DEALER AIDS AND DISTRIBUTION INFORMATION

TRIUMPH SPECIAL TOOL
PART # BLT 2019 (I.D. #S109C)
REAR HUB REMOVER

S-6

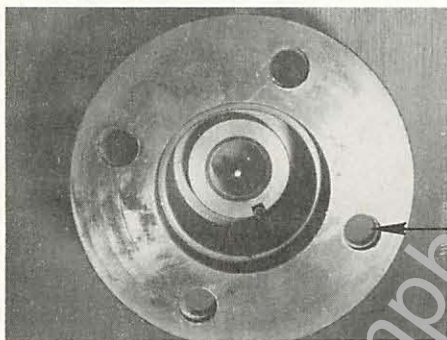
The Rear Hub Remover, Part # BLT 2019, can be used on the Triumph TR7; however, it is necessary to modify the tool by enlarging the four (4) bolt holes to $\frac{1}{2}$ " diameter as shown:

Drill the (4) holes
to $\frac{1}{2}$ " diameter

It is necessary to use Hub Nut Set, Part # BLT 2076, for the TR7 application. These nuts are being supplied with the required TR7 tools as per Dealer Aids and Distribution Information Bulletin, Issue ST-4.

Note : The rear hub remover can still be used on Marina, Spitfire, and GT6 even though it is modified.
